## **IMPORTANT SAFETY RECALL 20V-103**

**SN681**

**MODELS AFFECTED:** TM End Mount Aerial Devices

**SUBJECT:** Leveling Sensor Installation

**Issue:**

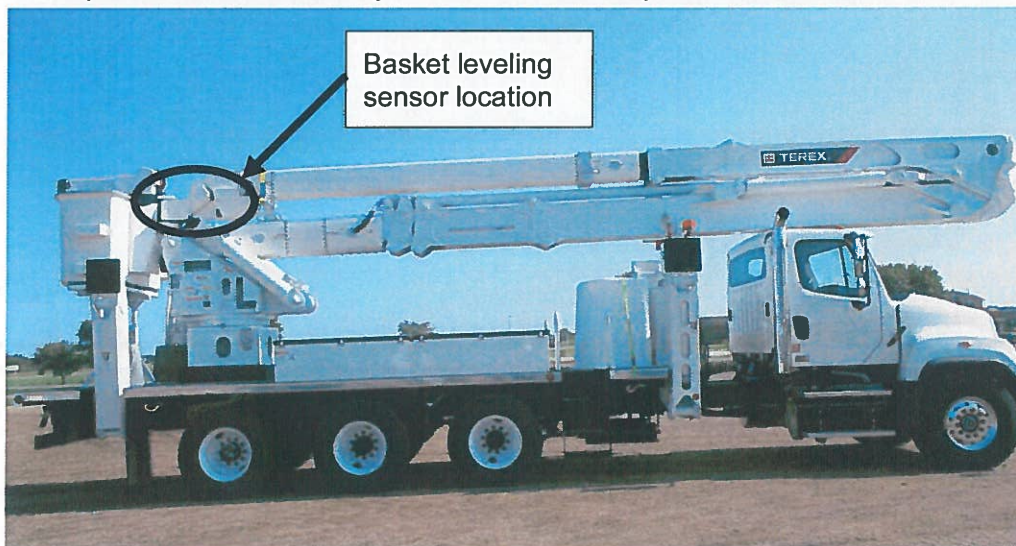
On Terex TM end mount aerial devices, manufactured from April 2014 through July 2019, one of the two basket level limit sensors at the boom tip may have been assembled upside down. The limit sensors prevent the platform from going more than 15 degrees from level if the electrical system malfunctions. The incorrect mounting of the level sensor may cause an out of level basket to continue moving more than 15 degrees out of level. **If the leveling system malfunctions it may cause the occupants to fall from the platform.**

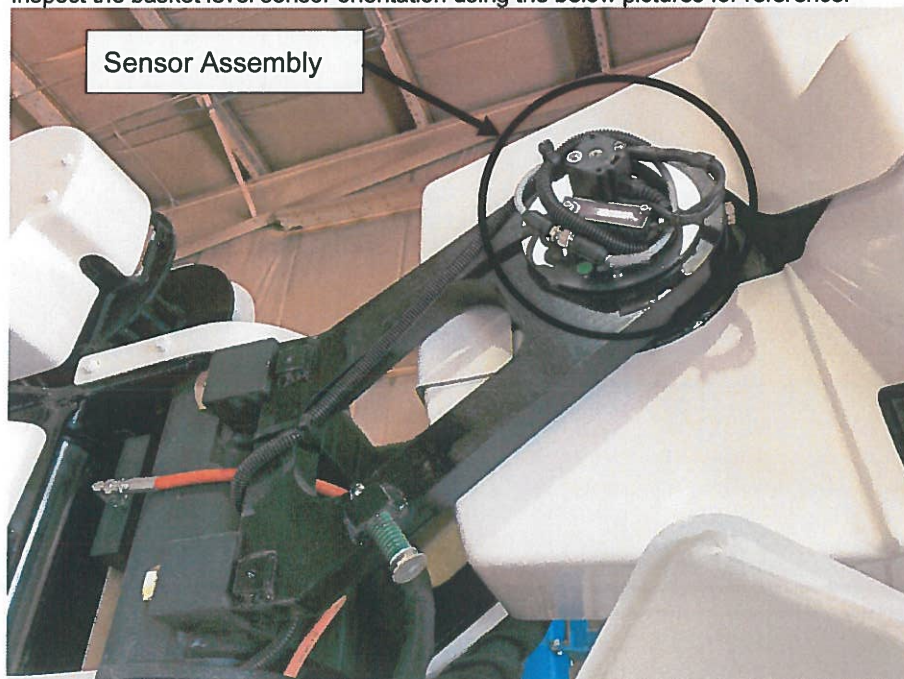
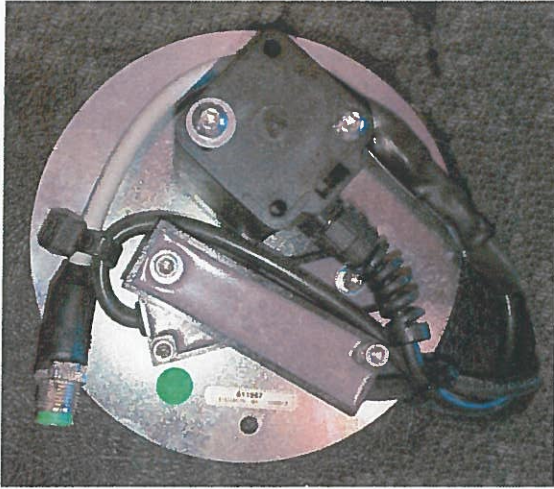
- a. Remove cover by removing the two polytop screws to access the basket level sensor.

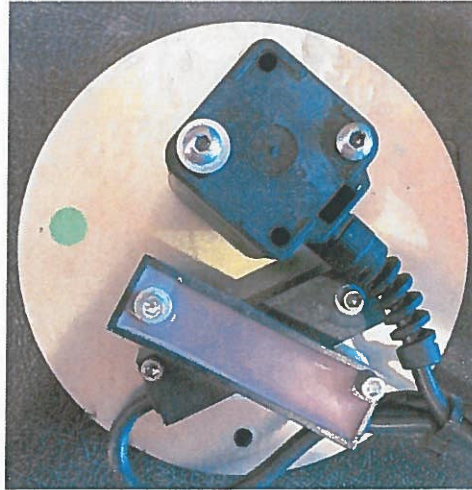
- b. Inspect the basket level sensor orientation using the below pictures for reference.

This bulletin applies if the Light colored potting visible on both sensors

This bulletin does **NOT** apply if the Light colored potting visible on top sensor only

3. If your unit has both sensors mounted with the light colored potting visible, this bulletin applies. Correct following the instructions in Field Service Kit Z1562. Take a picture before correcting the issue and another picture after correcting the issue. Send both pictures with the completion form including the serial number and date of correction to [utilities.warranty@terex.com](mailto:utilities.warranty@terex.com).
4. If your unit has the light colored potting visible only on the top sensor, and the wires coming out of the sensors below the mounting screw this bulleting does not apply and use can continue without restriction.
